INDESIT company

Model type:
AVXL105AUS

Commercial code:
F029663

1140960 Exploded views

Fig. n10402231

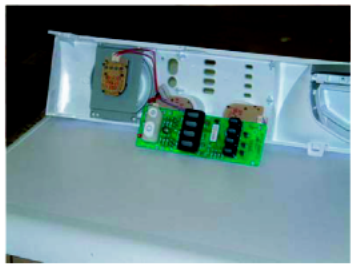
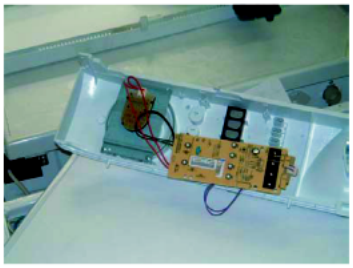
n1040331: Ariston LED restyling

From serial no. 40429.0001, models AVL, AVXL, AVSL, AML have been equipped with a new panel with well holes for the

ON/OFF and RESET buttons and flush plastic light diffusers in place of the projecting siliconed ones (see picture n10402231 Fig.02). These features determine whether an appliance is modified or premodification.
The modification has also involved the electronic card whose panel and display communication connectors are on the left and not at the back (see picture n10402232 Fig.2).

The codes affected by this modification are:

For model AVSL85PL only
C00109966 - PANEL + HANDLE AVSL85PL LC

For model AVSL85EU only
C00109956 - PANEL + HANDLE AVSL85EU LC

For both models
C00143338 - LED CARD EVOII AVL /BUILT-IN ARISTON
C00110115 - WHITE BUTTONS ON-OFF/RESET EVOII LED KIT
C00109854 - PANEL WIRING LBE EVOII
C00110055 - SILICONED BUTTONS AVL-AVSL
C00110059 - PANEL WIRING -DISPLAY 240000848B2.
C00111227 - WIRING MAIN - DISPLAY 24000084804B1 (POLARIZED).
The new parts are only interchangeable with the pre-modification ones if used altogether. They are not individually interchangeable.

n1040381: Drain pump with bayonet-style filter - front Loading Brembate

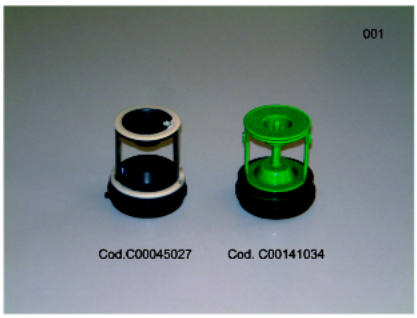
From serial no. 50720.0001 a new drain pump with bayonet-style filter has been installed on all front loading washing machines manufactured in Brembate.

New parts:
C00119307 - Drain pump
C00141034 - Pump filter kit

Premodification parts:
C00092264 - Drain pump
C00045027 - Pump filter kit

The new parts can be used instead of premodification ones.
